DATE PREPARED: <b>June 13, 2007</b>		<b>ISS PAYLOAD OFFICE PIRN/EXCEPTION FORM</b>		<b>PAGE 1 OF 5</b>	
Doc. No., <b>SSP 57213, Initial Release</b> Rev. & Title: <b>Alpha Magnetic Spectrometer (AMS) Interface Control Document</b>			PIRN No: <b>57213-NA-0011</b>		
TITLE: <b>AMS (Alpha Magnetic Spectrometer) – PVGF Cable Tie Down Exceedance</b>					
<b>Originator:</b> Name: <b>Trent Martin</b> Agency: <b>NASA JSC AMS Project Office / EA</b> Phone: <b>281-483-3296</b> Email: <b>trent.d.martin@nasa.gov</b>		<b>PIRN Type:</b> <input type="checkbox"/> Standard PIRN <input checked="" type="checkbox"/> Exception		<b>FAX Approval Signatures to this Number:</b> <b>314-777-2866</b>	
<b>Utilization Change Engineer:</b> Name: <b>Leonardo Cornejo</b> Agency: <b>Boeing PEI</b> Phone: <b>281-226-4644</b> Email: <b>leonardo.a.cornejo@boeing.com</b>		<b>SSCN/CR</b> <b>N/A</b>		<b>RELATED PIRN No.:</b> <b>N/A</b>

Agency Tracking No.: <b>57213-0007</b>		<b>SYSTEM/ELEMENT AFFECTED &amp; STAGE EFFECTIVITY:</b> <b>AMS – Launch through End Of Life</b>			
REASON FOR CHANGE OR REQUIREMENT(S) VIOLATION: <b>AMS exceeds PVGF cable tie-down requirement defined in SSP-57003, Paragraphs 3.7.3.3.4-B.</b>					
PAR

**Figure 3.7.3.3.4-AMS-01: AMS PVGF Cable Tie-Down Violation**

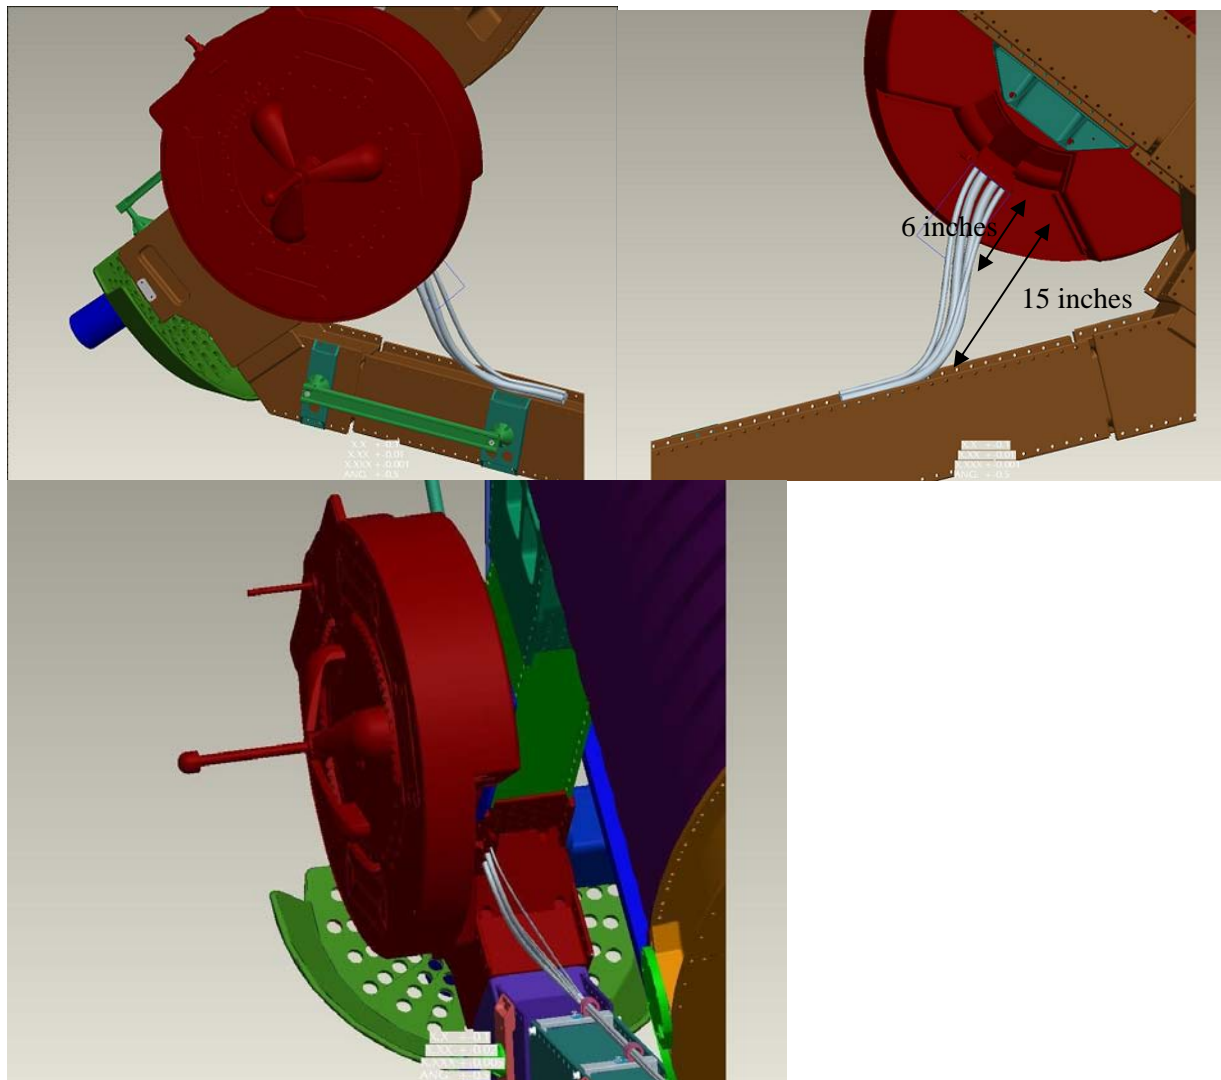
- B. The PVGF cable harness shall be secured to the payload within 6.0 inches of the cable harness exit bracket. The user shall be responsible for routing and securing the harness to ensure it is outside of the SSRMS and EVA clearance zone as specified in NSTS-21000-IDD-ISS, **except for the AMS payload that will secure the cable within ~15 inches as there are no other tie-down points as can be seen in Figure 3.7.3.3.4-AMS-01: AMS PVGF Cable Tie-Down Violation.**

As shown in the figure, there are no tie-down points available at the required 6 inch location. The first tie-down location is approximately 15” from the PVGF cable departure point. There are no alternative PVGF mounting locations. Rotating the PVGF does not work with the current design. Standard practice in the aerospace industry calls for cable tie-downs every 18 inches, so we believe that this should be acceptable.

A vibration issue was identified for this violation. ER3 requested an analysis from MacDonald Dettwiler Space and Advanced Robotics Limited (MDA). MDA's report SRMS.123638 Rev A determined that the PVGF cable exit clamp will have no structural issues. Based on this report, ER3 provided concurrence via e-mail (attached) on January 16, 2009. PEI agrees with MDA's analysis results.

Approve as written.

**Figure 3.7.3.3.4-AMS-02: PVGF EVA Bolt and SSRMS LEE EVA Bolt**

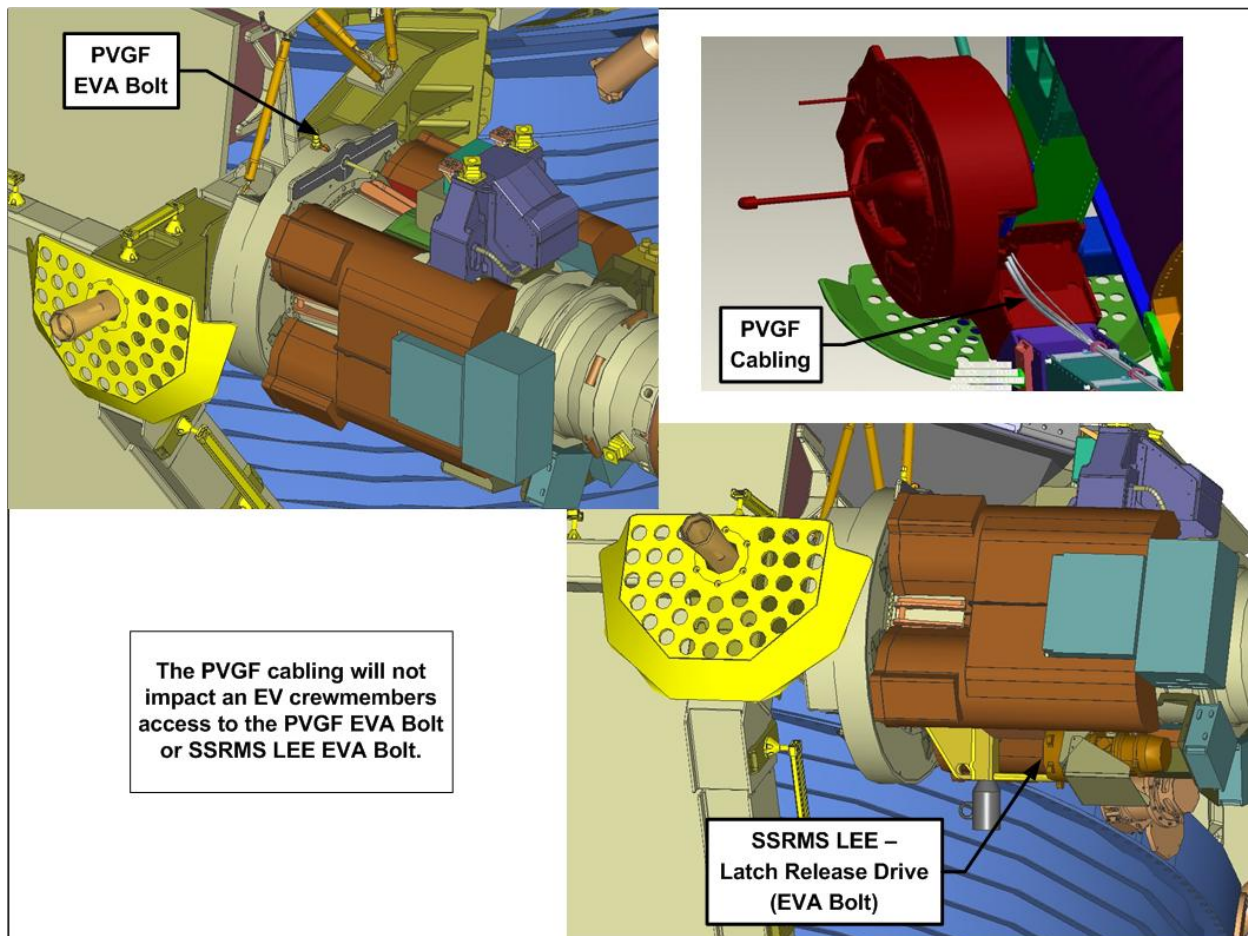
Per Crew Consensus Report (CCR): AMS NBL 11.12.02 (Attached), EVA access to the PVGF contingency release bolt is acceptable. Boeing EVA provided PEI with Figure 3.7.3.3.4-AMS-02: PVGF EVA Bolt and SSRMS LEE EVA Bolt (shown below) to demonstrate that the AMS PVGF will not impact a crewmember access to both of these EVA bolts. PEI concurs with CCR AMS NBL 11.12.02 and with Boeing EVA Figure 3.7.3.3.4-AMS-02 which demonstrate that the PVGF Cable tie-down requirement violation does not impact EVA.
